PRINCE GEORGE'S COUNTY Planning Department

### Detailed Site Plan Alternative Compliance <u>Clinton Market Place North</u>

### DSP-23006 AC-23005

#### SUBJECT: Detailed Site Plan DSP-23006 Alternative Compliance AC-23005 Type 2 Tree Conservation Plan TCP2-015-14-02 Waiver from Section 25-128(b) Clinton Market Place North

### **CIRCULATION EXHIBIT**

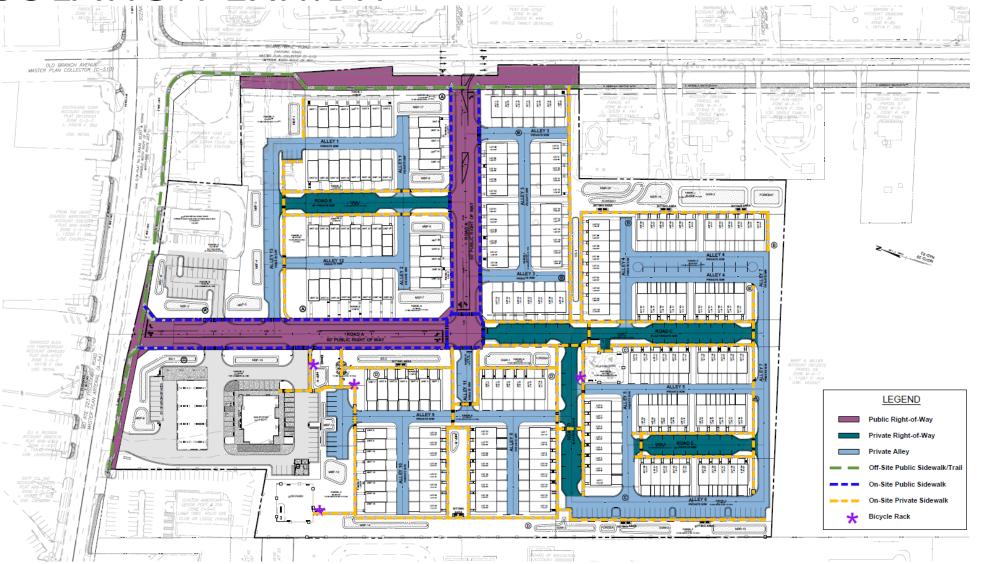
The circulation exhibit, submitted with this DSP, shows that the vehicular and pedestrian circulations within the site are planned and designed to be separated in order to achieve a safe, efficient, and convenient living environment for both pedestrians and drivers. Crosswalks are provided when both circulations intersect. Since the subject DSP includes both residential and commercial development, a relatively large size of a parking lot is included in the commercial development area. In addition to two internal vehicular entrances from Road A, there is only one direct vehicular entrance from MD 223, which provides a safe transition into the parking lot and minimizes conflict with off-site traffic. The design of this parking lot will discourage use as a through-access drive. The parking lot is designed to separate pedestrian and traffic circulations, except when both intersect, and is equipped with directional signs to support vehicular traffic flows freely within it. The parking lot includes a combination of sidewalks and striped crosswalks for people to safely access the convenience store. Three handicap-accessible parking spaces are located around the convenience store, with barrier-free pathways for easy access. A condition is included herein requiring the applicant to clearly label directional arrows, lane markings, and

### PERSPECTIVE - JENKINS 20' TOWNHOME

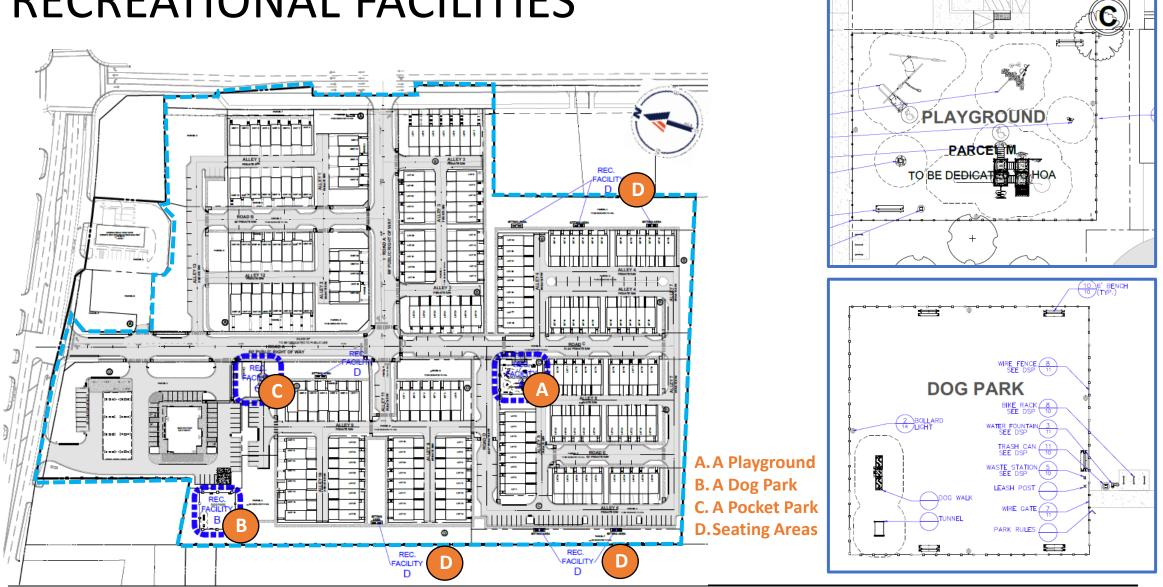
- c. Regarding architecture:
  - (1) Add the eight additional elevations (AB, AC, AD, AE, AF, AG, AH, AJ) for the Jenkins model to the model templates on Sheet 3, which will only be used for the lots fronting on Brandywine Road and facing the Surratt House.

Note: \*Eight (8) nonmasonry elevations of the Jenkins model are only used for the lots fronting on Brandywine Road and facing the Surratt House.
